FLYING HORSE NORTH FILING NO. 4
CONSTRUCTION DOCUMENTS
A TRACT OF LAND BEING A PORTION OF SECTION 30, TOWNSHIP 11 SOUTH,
RANGE 65 WEST OF THE 6TH P.M., AND A PORTION OF SECTION 31, TOWNSHIP 11
SOUTH, RANGE 65 WEST OF THE 6TH P.M.,
CITY OF COLORADO SPRINGS, COUNTY OF EL PASO, STATE OF COLORADO

As-Built Document
PE Approval by: Richard D. Lyon
(Stamp Appended on this Plan Sheet)
09/24/2026 10:43:30 AM

FLYING HORSE NORTH FILING 4
PRI #2, LLC.
EL PASO COUNTY, CO

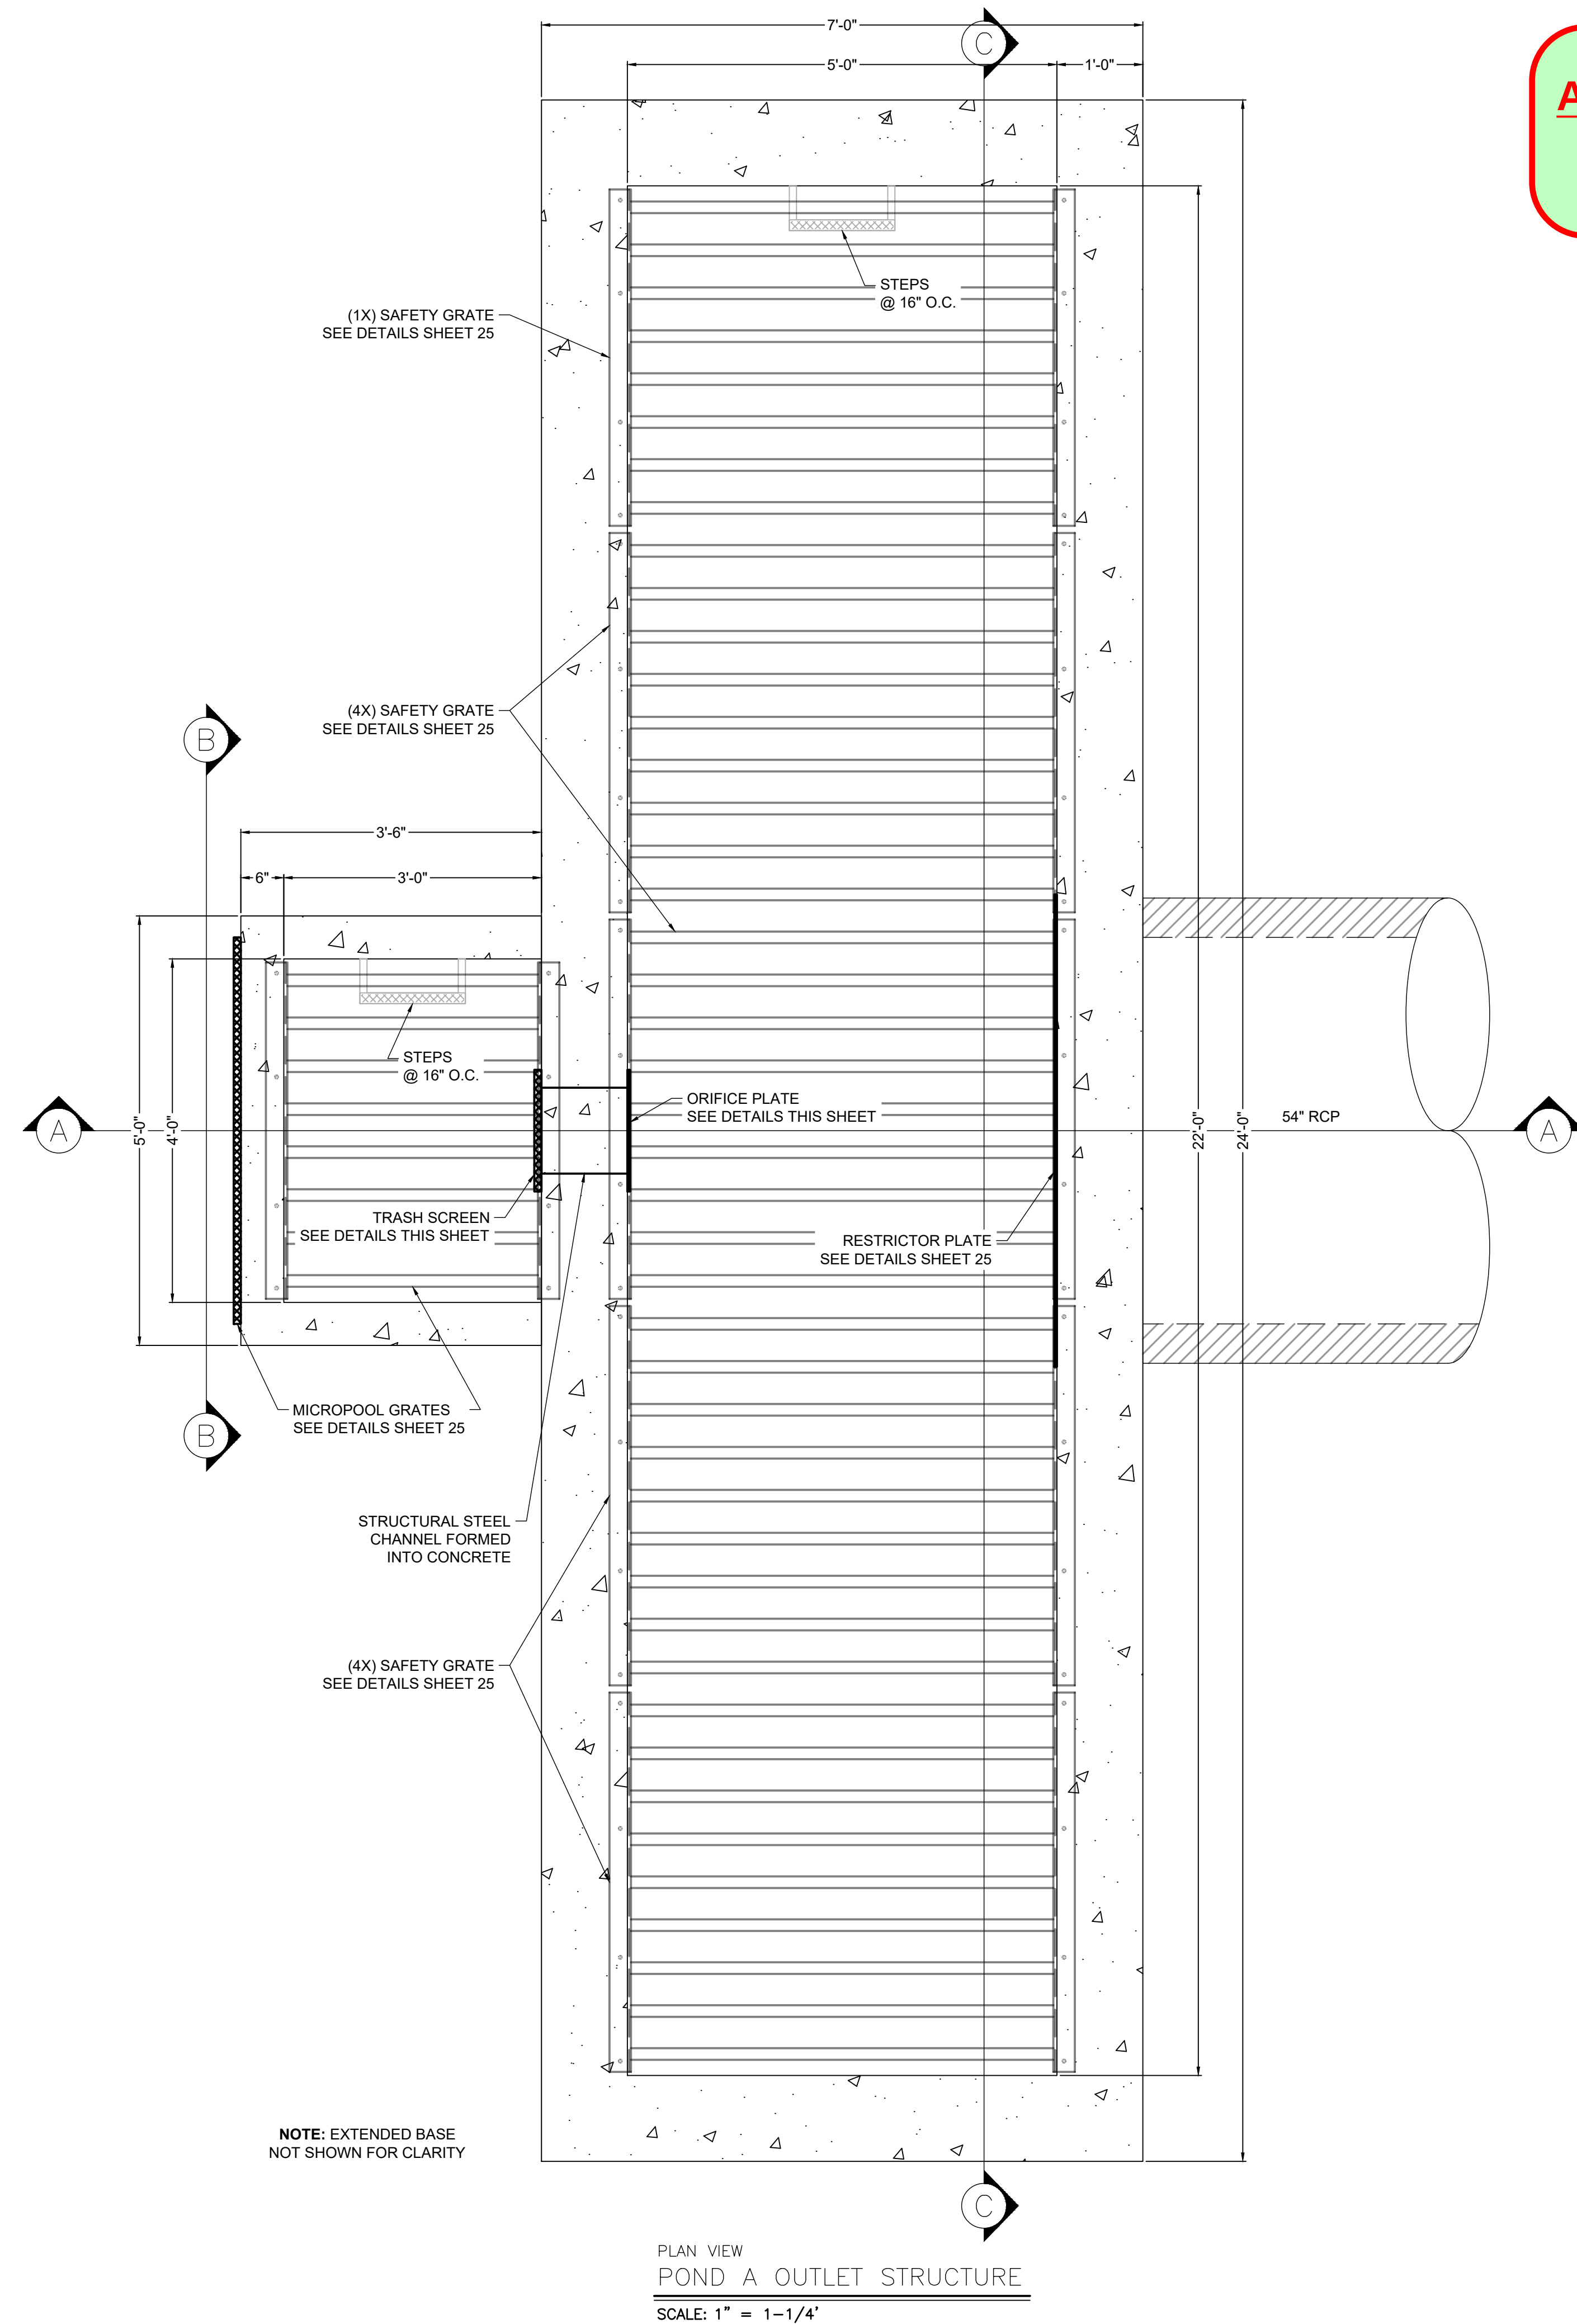
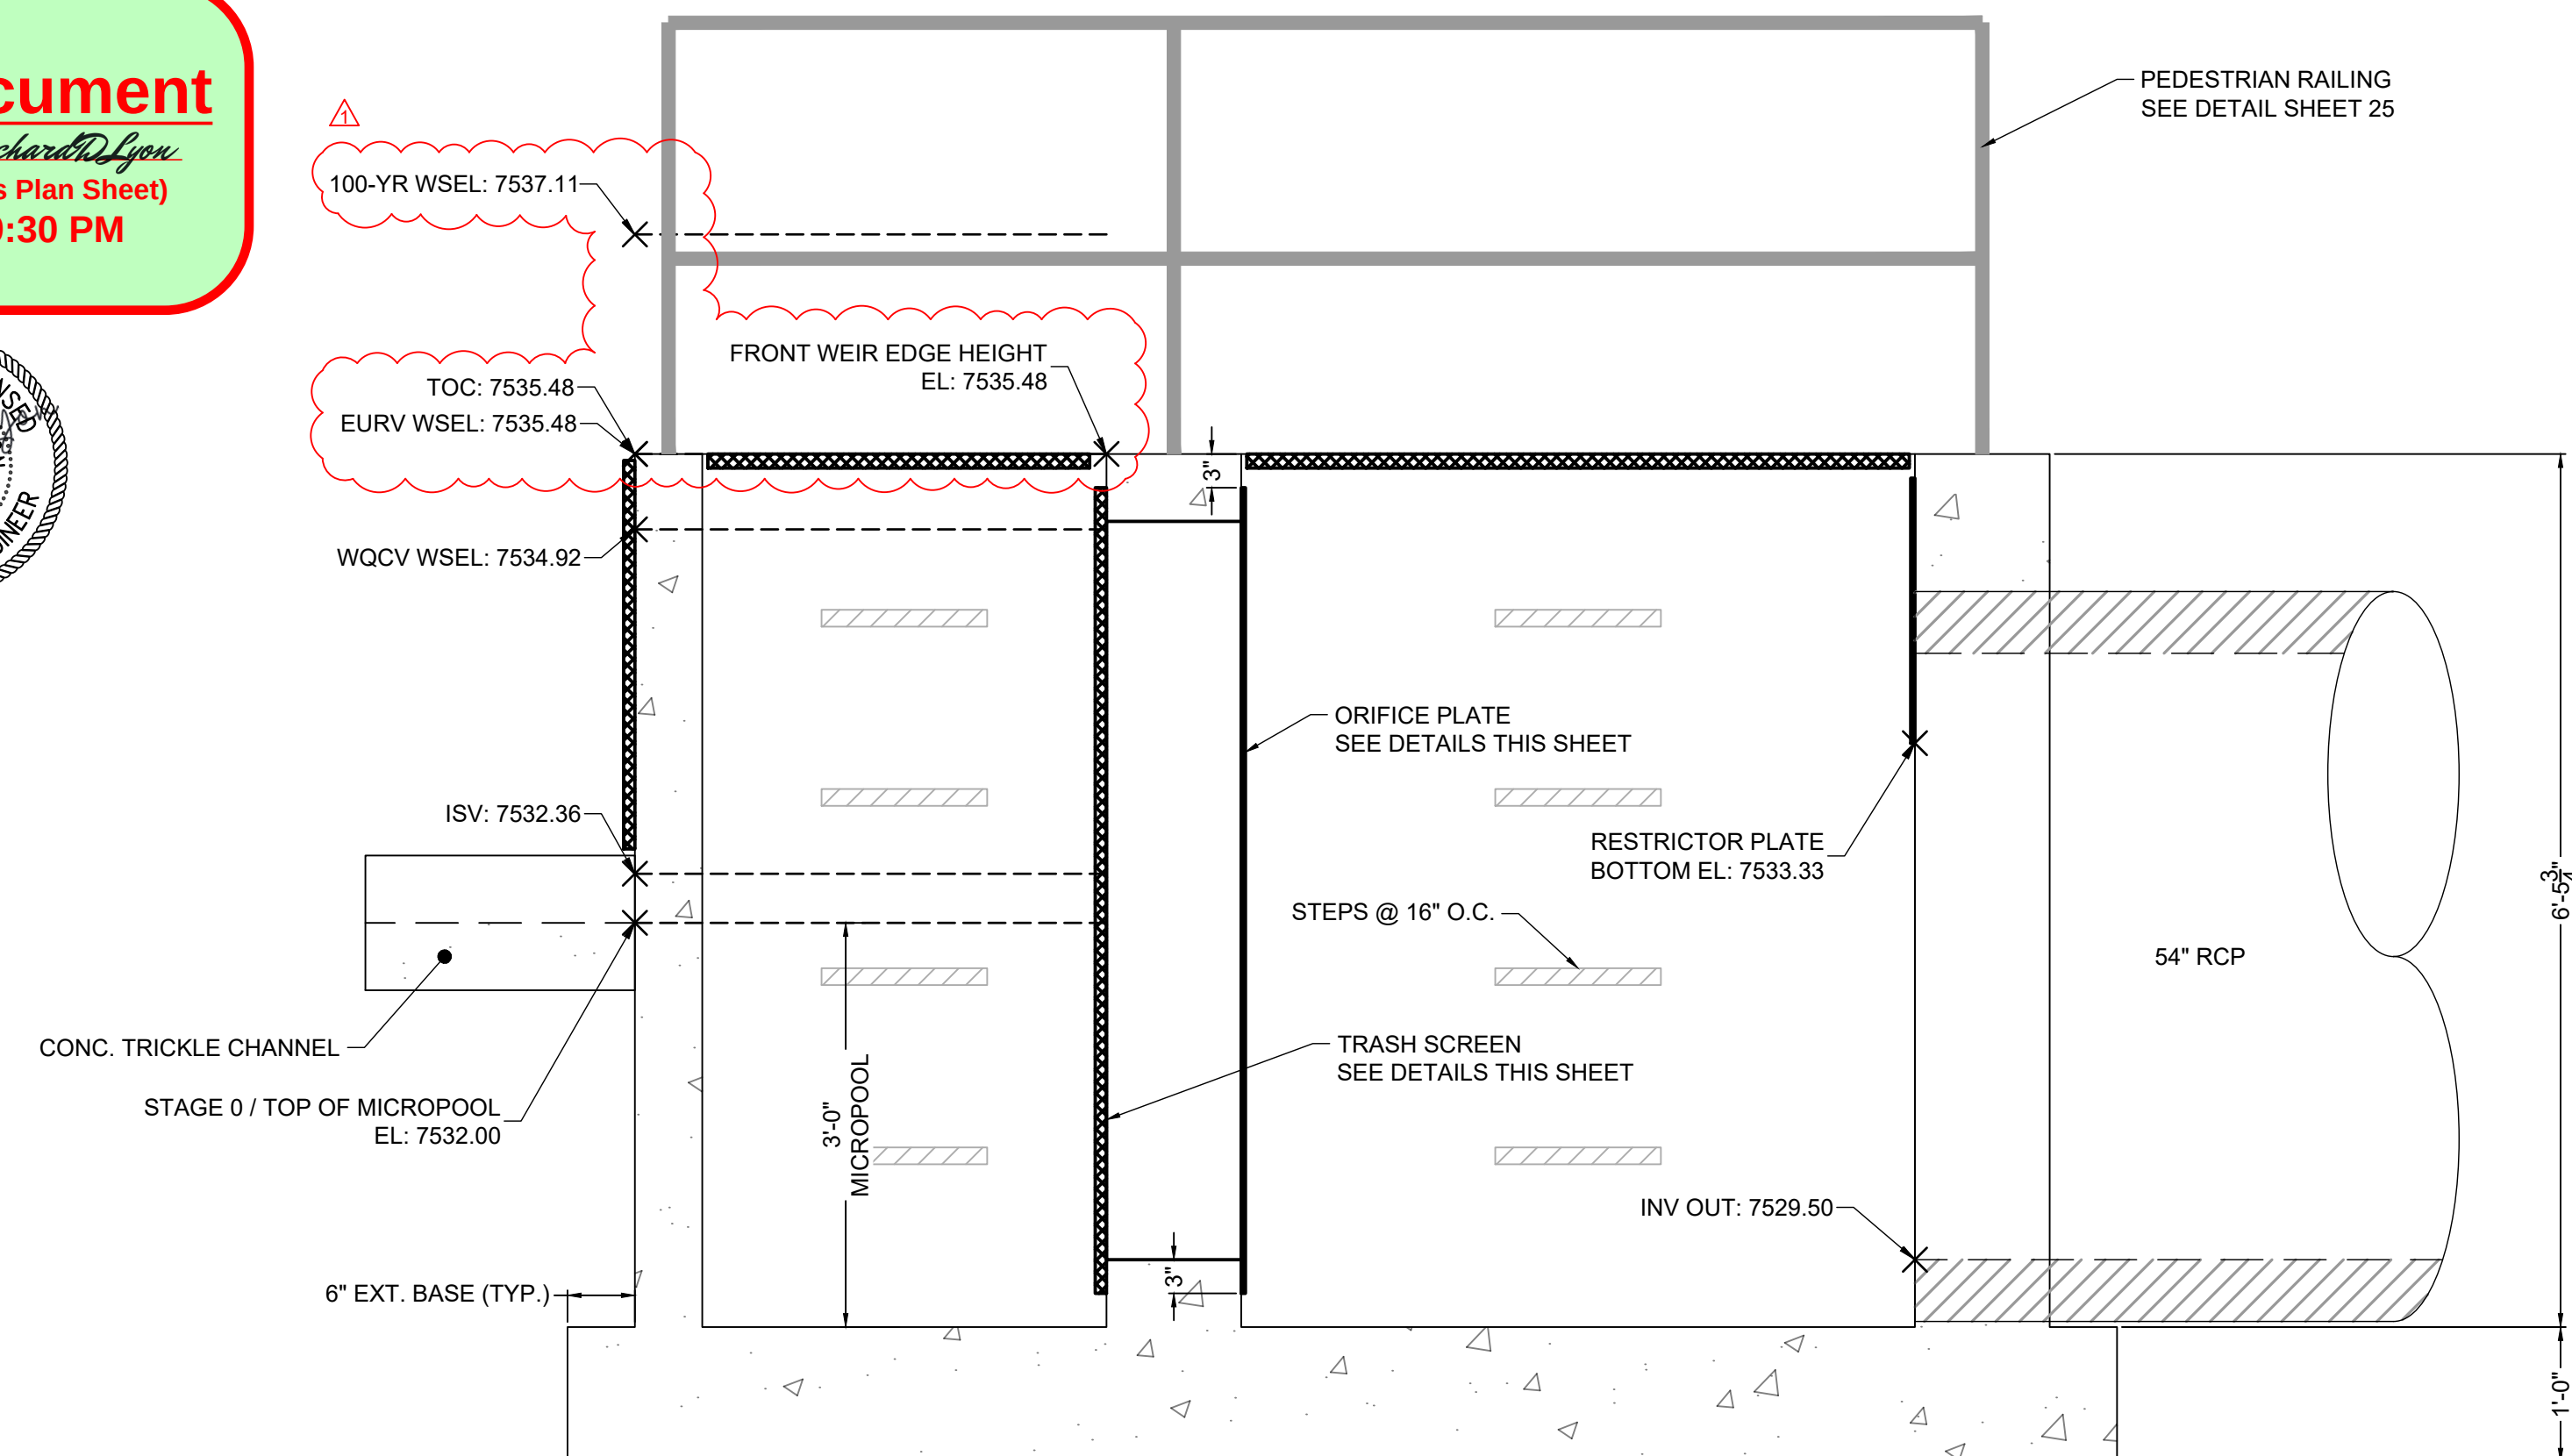
why is the area redlined, but the other 3 values for this orifice are not red (they all changed from the original design)?

For consistency with redlines on this sheet and others, just get rid of the line where you crossed off 2.12 and put the next elev below it, because you havent done that anywhere else.
Typical comment for all 3 orifices.
